Amendment C278: Sunlight to public parks

Submission from the Carlton Residents Association Part 1

1 March 2021

Planning Panels Victoria Presentation

The Station Street Park Case Study

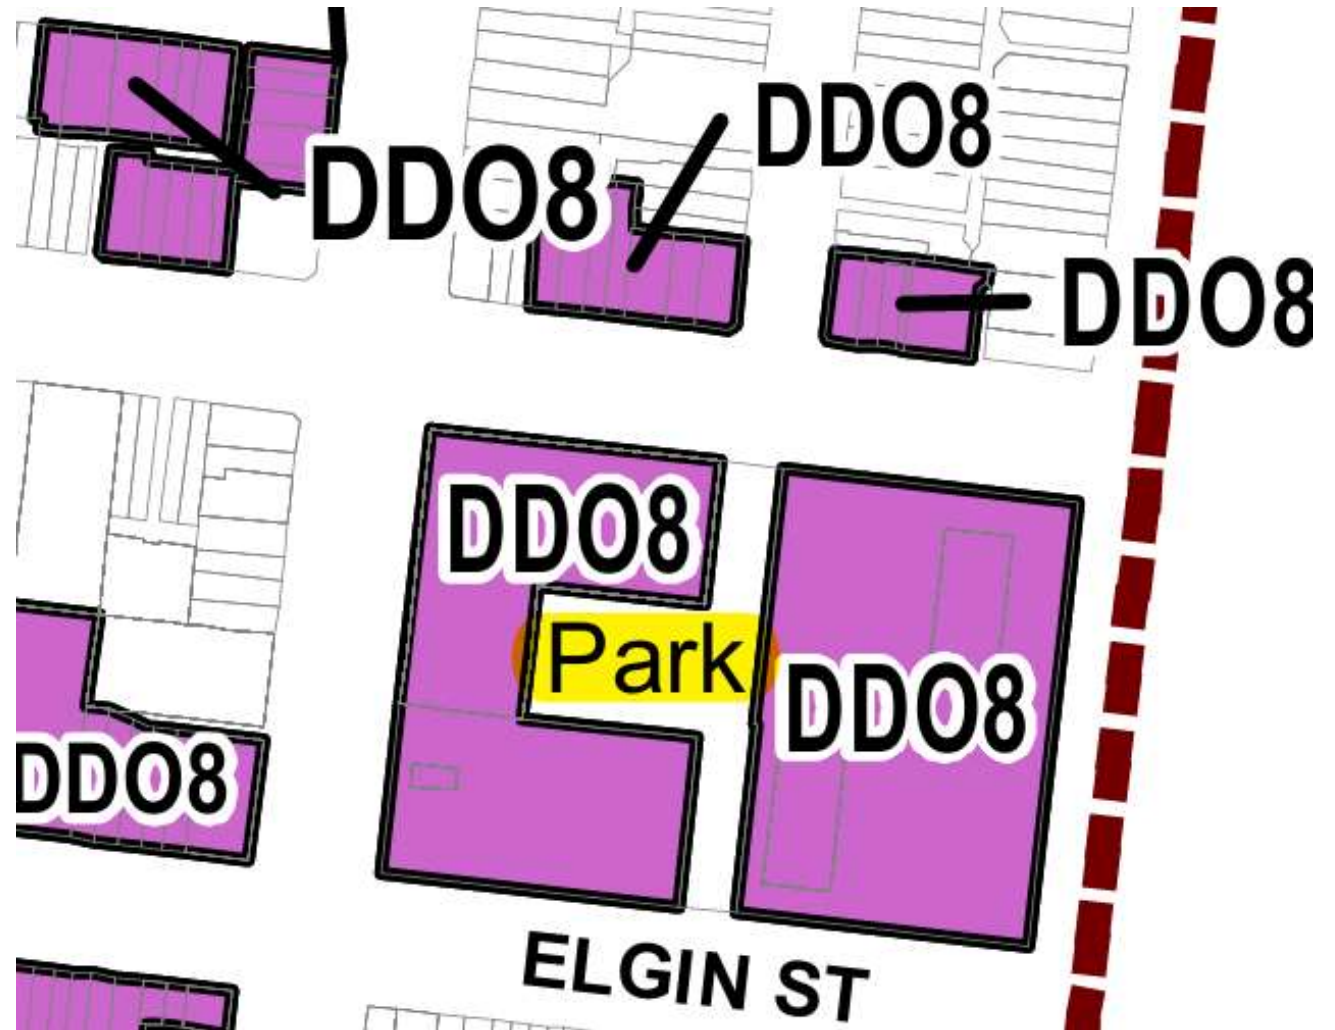
Extract from the Exhibition version of the DDO8 Map 05 [from the proposed Amendment C278 to the Melbourne Planning Scheme] showing the location of the Station Street Park.

This Park is located in a Growth Area within Development Plan Overlay 8, with the principal built form guidance included in the Approved Development Plan for this Precinct.

Although the new buildings in this precinct are within the 5 to 8 storey range, which results in extensive shadows over the park, this open space has been designated as a Park Type 1 [see following images]

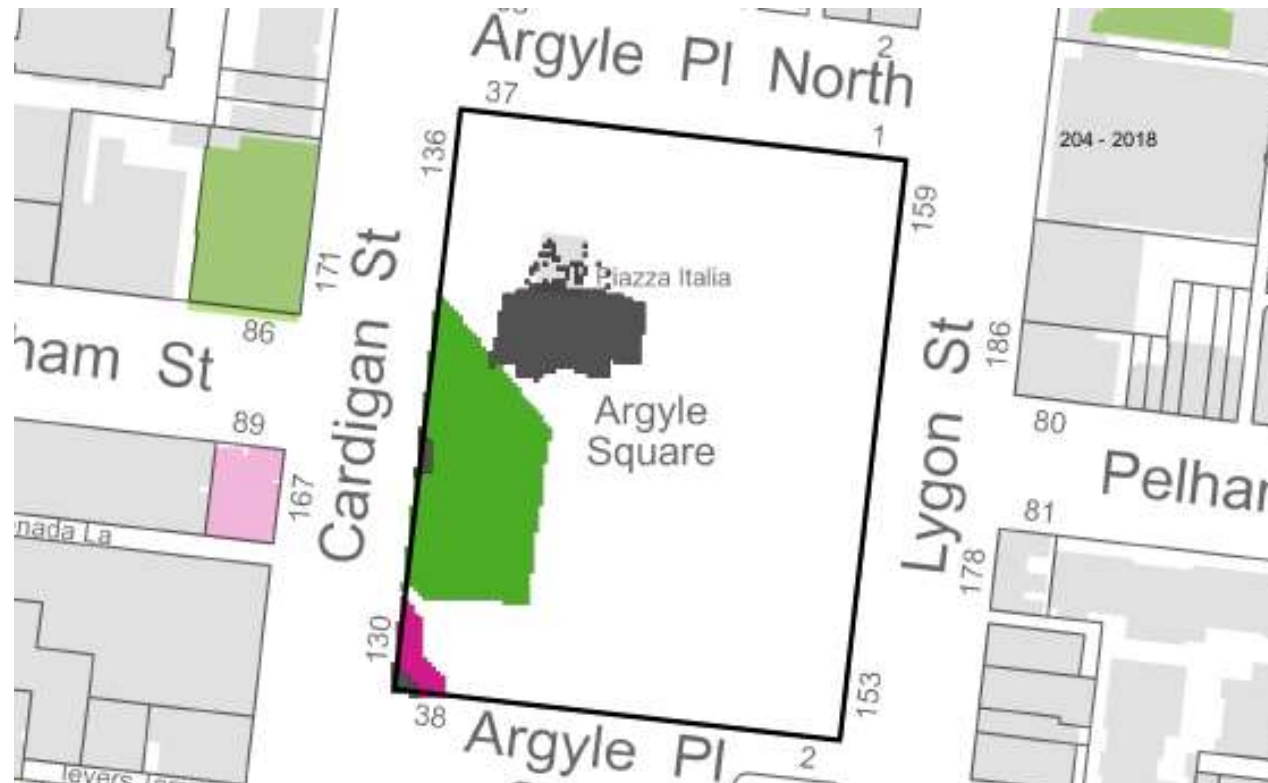
- DDO47, which surrounds Argyle Square, includes Design Objectives which seek to **“maintain the predominant low scale nature of the area”** AND to **“ensure development supports high levels of pedestrian amenity related to access to sunlight and sky views and a pedestrian friendly scale.”**

- Further, the table to Schedule 47 nominates the maximum building height for this low scale area as 4 storeys. **“An application to exceed the Maximum Building Height must demonstrate how the development will continue to achieve the Design Objectives and Built Form Outcomes of this schedule and any local planning policy requirements.”** The Built form Outcomes are also quite unambiguous: **“New development respects and is consistent with the built form especially low scale of the existing older building stock in the street,”** and **“Development that does not overshadow Argyle Square ... between 11am and 2pm on 22nd September and 22nd March.”**
